# NEXT MAJOR WATER SUPPLY SOURCE FOR PERTH (POST 1992)

WATER AUTHORITY OF WESTERN AUSTRALIA

Report and Recommendations  
of the  
Environmental Protection Authority

Environmental Protection Authority  
Perth, Western Australia  
Bulletin 343 August 1988

Figure 1): North Dandalup Dam; Plan of Works

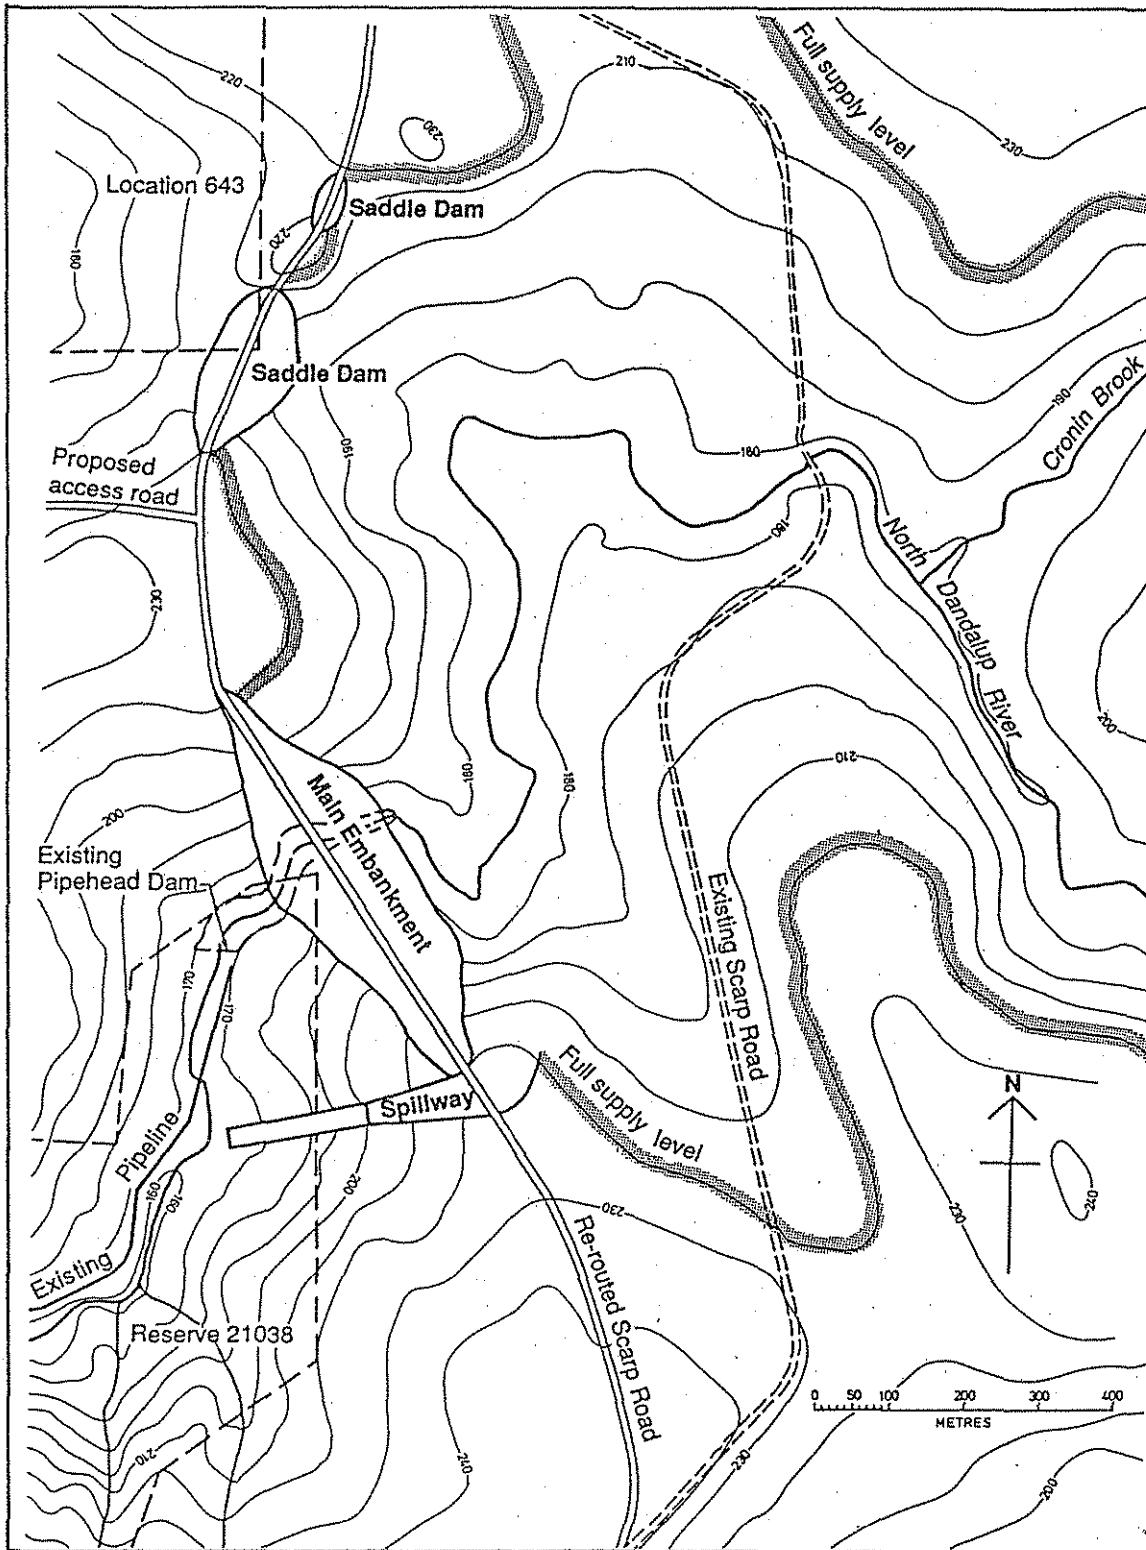
Four main areas of impact arise from the proposed construction of this dam, namely: the reservoir area; the dam wall (including the two saddle dams) area; the immediate downstream area; and, the outflow area in the escarpment and Swan Coastal Plain. Minor aspects, although of importance, include such things as road deviations.

Another matter of concern is the impact of spillway water on the immediate discharge point in the stream and the stream zone downstream especially in relation to possible threats to the integrity and purpose of the System 6 recommendations.

The Environmental Protection Authority recommends that prior to construction, the Water Authority of Western Australia provide, to the satisfaction of the Environmental Protection Authority, an Environmental Management Programme for the North Dandalup dam to include details of the following:

- (i) environmental consequences of road deviations;
- (ii) source of construction materials; and
- (iii) the management of the proposal in terms of its environmental impacts in the reservoir, dam and immediate downstream sections of the river and valley during and following the construction phase. This includes the mitigation of potential impacts upon the habitats in the affected areas.

The Environmental Protection Authority recommends that prior to construction, the Water Authority of Western Australia provide to the satisfaction of the Environmental Protection Authority, a management plan, prepared in consultation with the Department of Conservation and Land Management, for Reserve C21038. This management plan should include the following:

- (i) proposals for the excision of the dam wall and spillway areas from Reserve C21038;
- (ii) management of public access to the Reserve;

- (iii) impact of spillway waters on the stream zone;
- (iv) impact of the pipeline and maintenance road; and
- (v) rehabilitation of the pipehead dam site.
